MANDATORY**MTL-34-01****TITLE**

NAVIGATION - GPS-4000S GLOBAL POSITIONING SYSTEM SOFTWARE UPDATE

Service Information Letter GPS-4X00()-19-3 REVISION NO. 2

NAVIGATION - GPS-4X00() - SOFTWARE UPDATE FOR UNIVERSAL TIME COORDINATED
(UTC) TIME OFFSET AND GNSS POSITION NEAR 180 DEGREES WEST LONGITUDE
(CONVERTS BLACK LABEL CPN 822-2189-100 TO BLACK LABEL CPN 822-2189-101)

Map
Figure 1

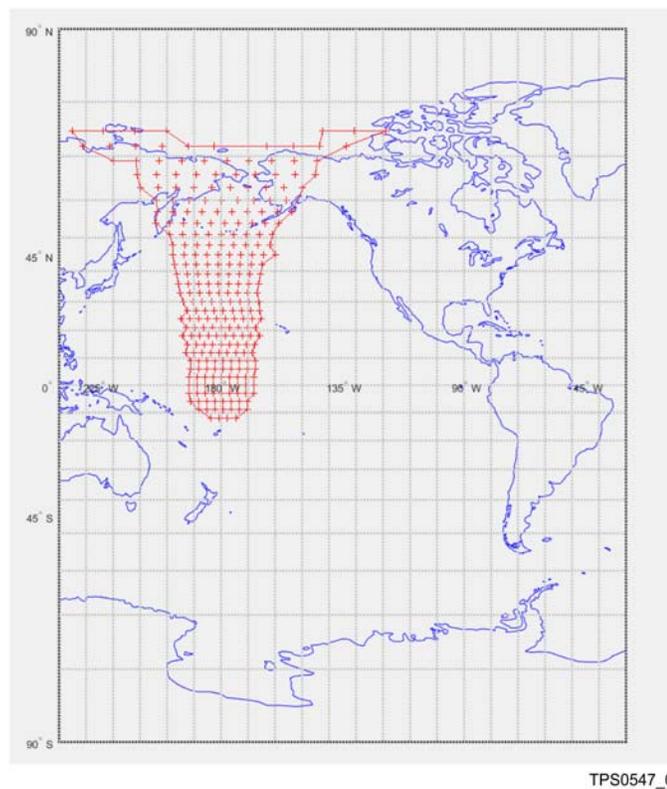
- (1) The Root Cause has been identified as an improper implementation in the computation of the longitude at which the GPS signal penetrates the ionosphere when the satellite is located across 180 degrees W Longitude.
- (2) The affected region is limited to the area within the solid red line boundary indicated in the attached map. The region extends 20 degrees on either side of 180 degrees W Longitude and extends from the Northern Hemisphere to 10 degrees Latitude in the Southern Hemisphere. Refer to Figure 1.

- (3) The potential reduction in position accuracy caused by the computational issue prevents the GPS-4000S, CPN 822-2189-100, from supporting LPV approaches at LPV-equipped airports in the affected region.
- (4) Un-announced, but bounded reduced positional accuracy in the affected region limits operations to RNP 0.3 NM, or higher (Positional error will be bounded to 0.3 NM but may not be bounded by the protection level (HPL) that is output by the GNSS).

- (1) A software update that corrects this issue is targeted to be available in Q1 2020.
- (2) Until that software update is available, operational limitations will need to be applied. The operational limits are:
 - (a) Do not use the GPS-4000S, CPN 822-2189-100, to perform LPV approaches at airports in Alaska listed below. There are no airports outside of Alaska that are in the affected region that support LPV approaches at the time of this SIL publication. LPV-equipped airports will be monitored on every database update and if additional LPV-equipped airports are identified, this SIL will be updated.
 - (b) Do not perform operations that require an accuracy better than RNP 0.3 NM (For example, 0.1, 0.11, 0.15, etc.) in the region identified in the above map (+/- 20 degrees of 180 degrees W Longitude) or at the airports in Alaska listed below.
